Public Review Draft

Proposed Addendum q to Guideline 36-2018, High-Performance Sequences of Operation for HVAC Systems

Addendum q to Guideline 36-2018

Figure 5.20.4.3 Control diagram for FCU.

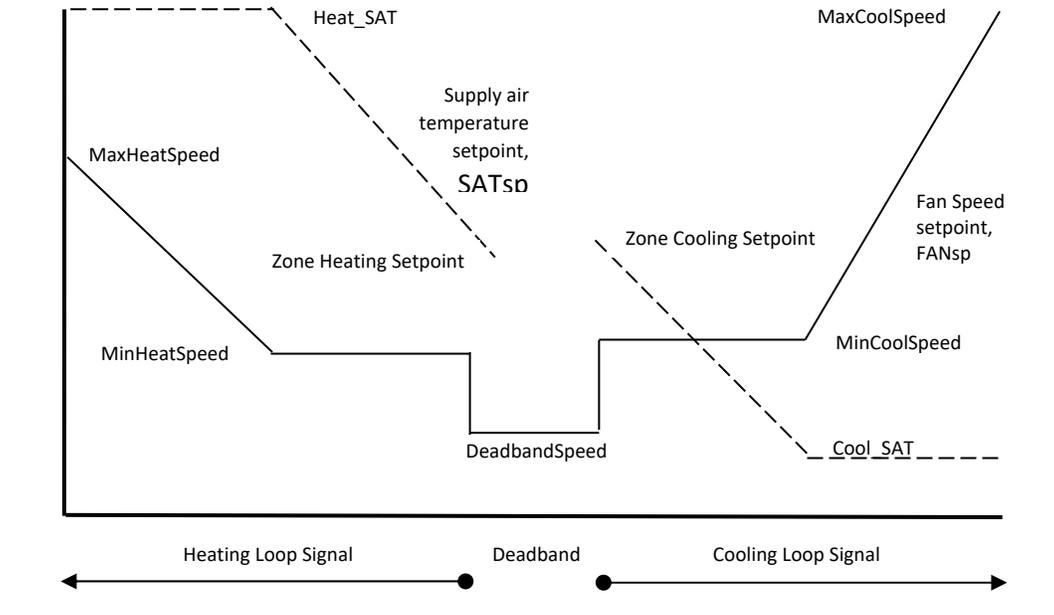
5.20.4.3. When the supply fan is proven on, fan speed and supply air temperature set points are controlled as shown in Figure 5.20.4.3. The points of transition along the x-axis shown and described are representative. Separate gains shall be provided for each section of the control map, that are determined by the contractor to provide stable

control. Alternatively, the contractor shall adjust the precise value of the x-axis thresholds shown in Figure 5.20.4.3 to provide stable control.

a. If there is a heating coil, when Zone State is Heating

1. For a heating-loop signal of 100% to 50%, FANsp is reset from MaxHeatSpeed to MinHeatSpeed.

2. For a heating-loop signal of 50% to 0%, FANsp set point is MinHeatSpeed.

3. For a heating-loop signal of 100% to 50%, SATsp is Heat_SAT.

4. For a heating-loop signal of 50% to 0%, SATsp is reset from Heat_SAT to the active zone heating setpoint.

5. The heating coil shall be modulated with a PID loop to maintain the discharge temperature at SATsp.

6. Cooling coil OFF.

b. When Zone State is Deadband

1. FANsp shall be DeadbandSpeed. If DeadbandSpeed is zero, shut the fan off.

2. Cooling coil OFF.

3. Heating coil OFF.

c. If there is a cooling coil, when Zone State is Cooling

1. For a cooling-loop signal of 0% to 50%, FANsp is MinCoolSpeed.

2. For a cooling-loop signal of 50% to 100%, FANsp is reset from MinCoolSpeed to MaxCoolSpeed.

3. For a cooling-loop signal of 0% to 50%, SATsp is reset from the active zone cooling setpoint to Cool_SAT.

4. For a cooling-loop signal of 50% to 100%, SATsp is Cool_SAT.

5. The cooling coil shall be modulated with a PID loop to maintain the discharge temperature at SATsp.

6. Heating coil OFF.

Figure 5.20.6.2 FCU operating states.

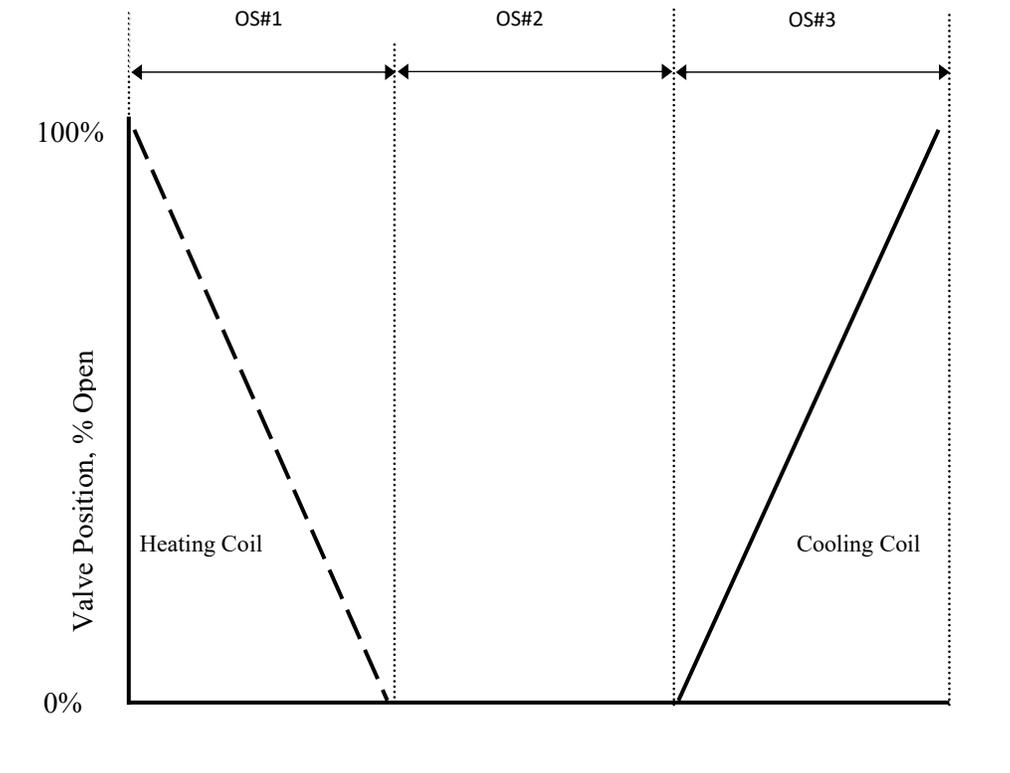
5.20.6.2. The OS of each FCU shall be defined by the commanded positions of the heating-coil control valve and cooling-coil control valve in accordance with Table 5.20.6.2 and Figure 5.20.6.2.

Operating State	Heating Valve Position	Cooling Valve Position
#1: Heating	> 0	$= 0$
#2: Cooling	$= 0$	> 0
#3 No Heating or Cooling	$= 0$	$= 0$
#4 Unknown	No other OS applies

The OS is distinct from, and should not be confused with, the zone status (cooling, heating, deadband).

OS#1 through OS#3 (see Table 5.20.6.2) represent normal operation during which a fault may nevertheless occur if so determined by the fault condition tests in Section 5.20.6.6. By contrast, OS#4 may represent an abnormal or incorrect condition (such as simultaneous heating and cooling) arising from a controller failure or programming error.
